Santa Clara Valley Open Space Authority
Llagas Creek Bridge and Day Use Area Project
Initial Study/Mitigated Negative Declaration
Response to Comments Memorandum

1 INTRODUCTION

WATER SURFACE PROFILES FROM HEC-RAS MODEL

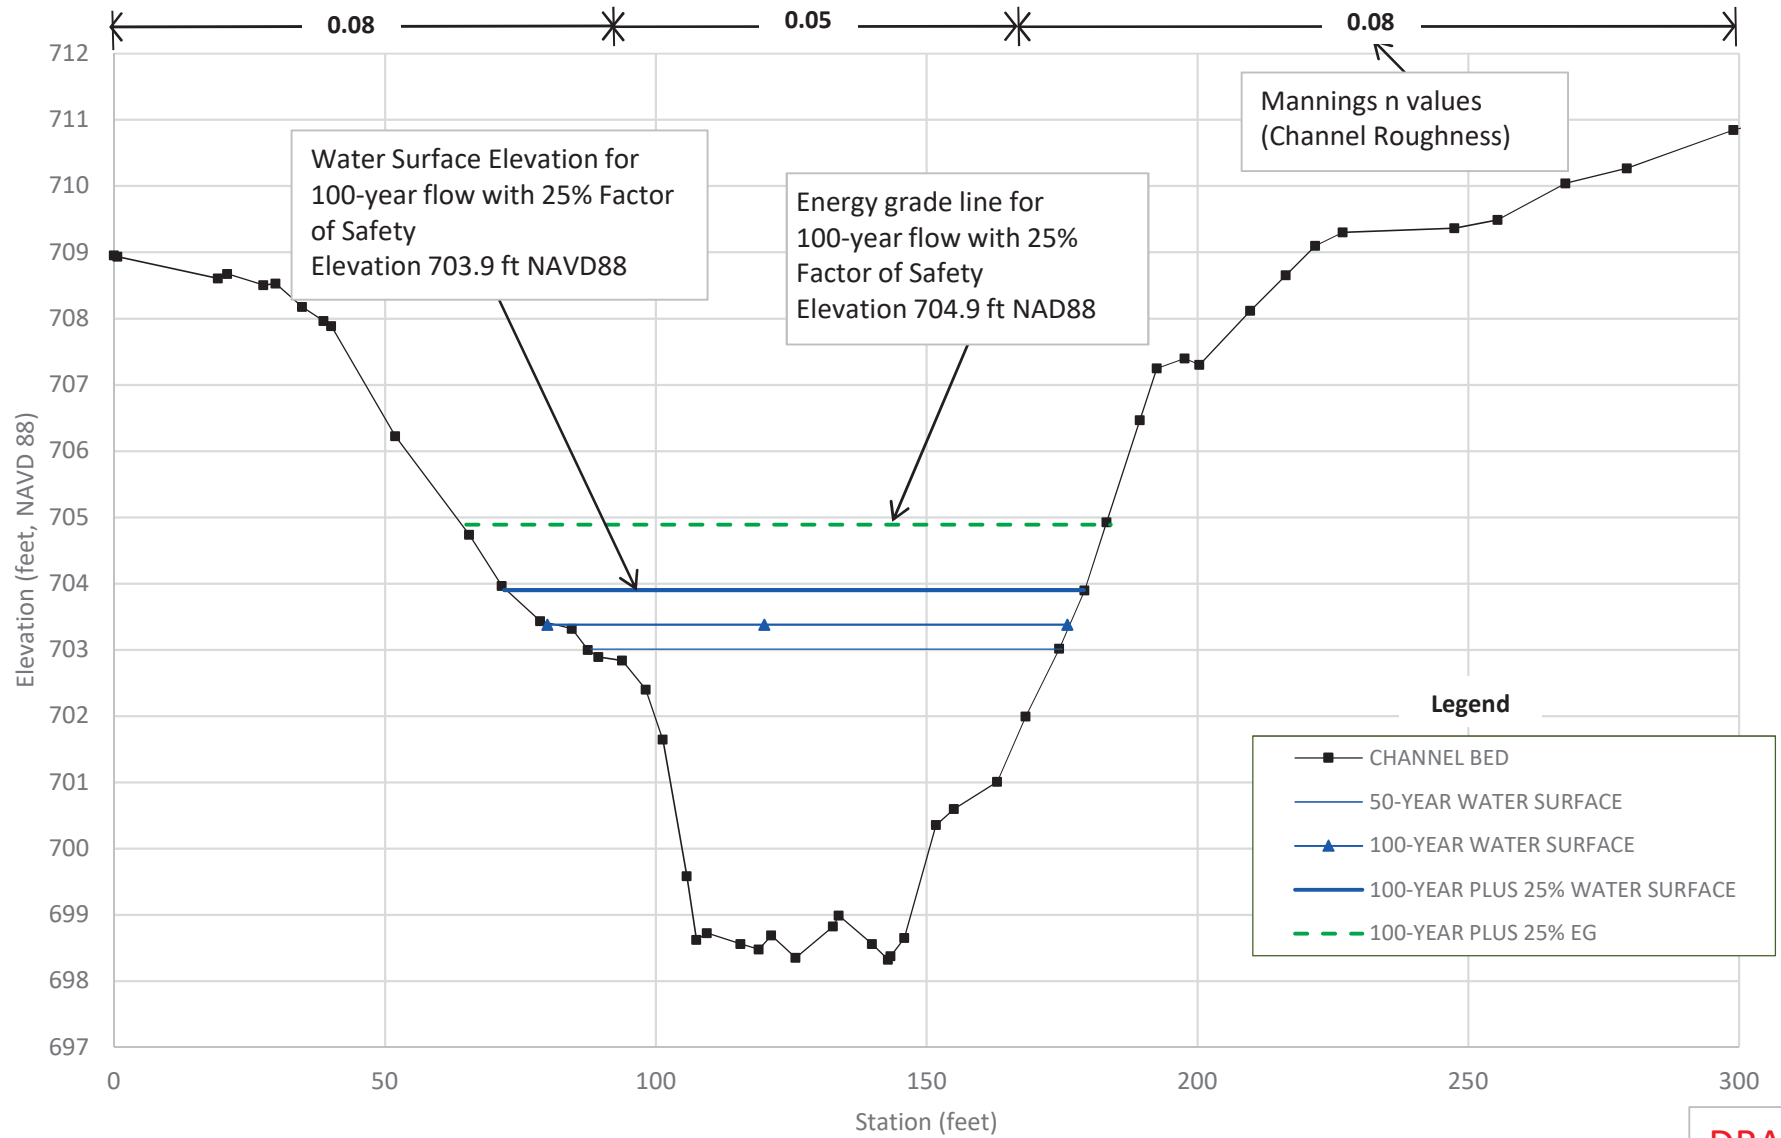
Comment 3-2: Additionally, the flow capacity of the bridge should be quantified, along with the flood event (magnitude and recurrence interval) that can pass through the bridge.

Comment 3-3: The IS/MND should demonstrate that the bridge will not impede, or block flows during the 100-year flood event. Section 3.10.2.C.III asserts that the proposed project will not substantially impede or redirect flows, however the IS/MND does not provide any basis for this statement.

Response 3-2: The comment states that the flow capacity of the bridge should be quantified, including the flood event that can pass through the bridge. The flow capacity of the bridge was quantified in Waterways Consulting, Inc.'s *Llagas Creek Bridge at Rancho Canada del Oro Open Space Preserve, Hydraulic Modeling Results* Technical Memorandum dated July 15, 2021 (Appendix B). This study informed the design and engineering of the bridge and abutments. The comment does not raise an issue regarding the environmental analysis of the project impacts in the Draft IS/MND; therefore, no additional response is required.

Response 3-3: The comment asserts that the IS/MND should demonstrate that the bridge would not impede, or block flows during the 100-year flood event. As discussed on page 3-63 of the IS/MND, the project area is not within a flood hazard zone designated by the Federal Emergency Management Agency (FEMA). Flood hazards zones designated by FEMA identified on the Flood Insurance Rate Map are identified as Special Flood Hazard Areas (SFHAs). SFHAs are defined as the area subject to flooding by the 1-percent annual chance of flood, which is also referred to as the base flood or 100-year flood. Therefore, because the project area is not within a flood hazard zone designated by FEMA, it is not within a 100-year flood zone and the bridge therefore will not impede, or block flows during the 100-year flood event. In addition, the bridge has been designed by the project's consultant engineers to not impede or block flows during the 100-year flood event. Refer to Waterways Consulting, Inc.'s *Llagas Creek Bridge at Rancho Canada del Oro Open Space Preserve, Hydraulic Modeling Results* Technical Memorandum dated July 15, 2021 (Appendix B).

As shown on Figure 2 and Figure 3, the estimated water surface elevation at the proposed bridge site for the design flood is 703.8 feet NAVD 88. A side calculation completed previously in Hydraflow² estimated the design flood water surface elevation to be 703.7 feet NAVD, which corroborates the HEC-RAS result, generally considered a more complex and robust calculation of water surface elevation.
